Servicing / Technical bulletin number: 062

Subject: Crewfit 165N Sport Harness Webbing modification removal

DESIGN CODE: 01194H
AMENDMENT SHEET

Amendment to 01194H Crewfit Sport with Harness

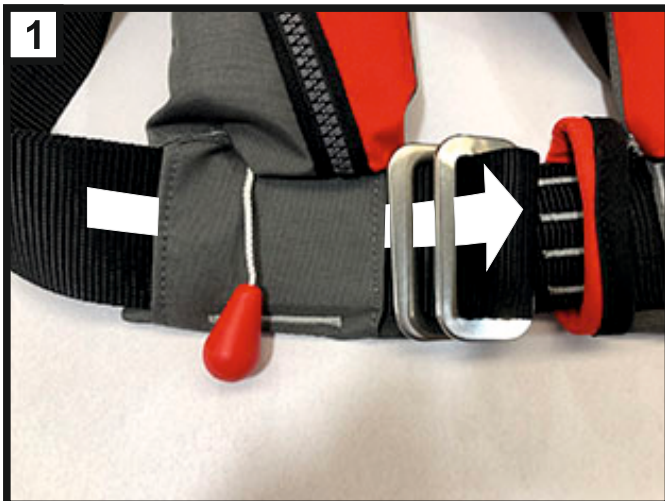
Removal of the webbing mod kit can be achieved without the need to un-thread the webbing or un-fastening the buckle.

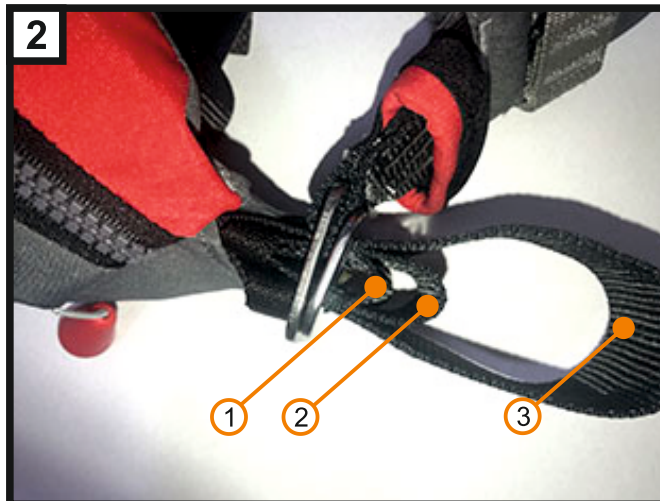
Push/pull the webbing through the buckle to give a clear view of the webbings

There will be three webbings visible
 1 50mm Buckle retainer
 2 50mm webbing mod kit
 3 50mm belt

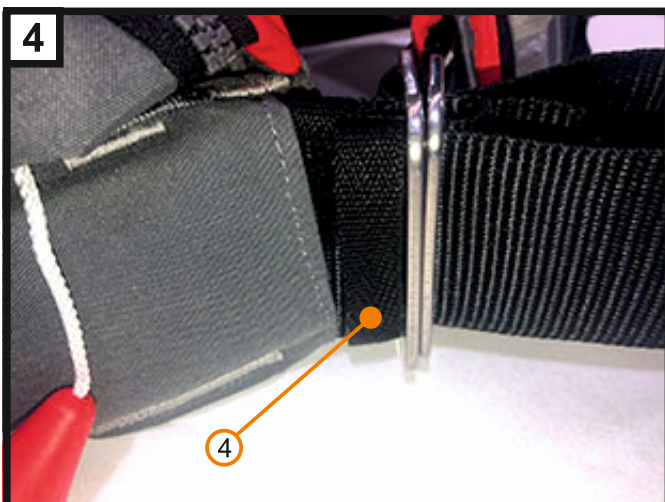
Cut the middle webbing (50mm webbing mod kit)

Cut the 10mm webbing (4) on the front of the belt, taking care not to cut the cover or the belt.

Remove and discarded the cut webbing.
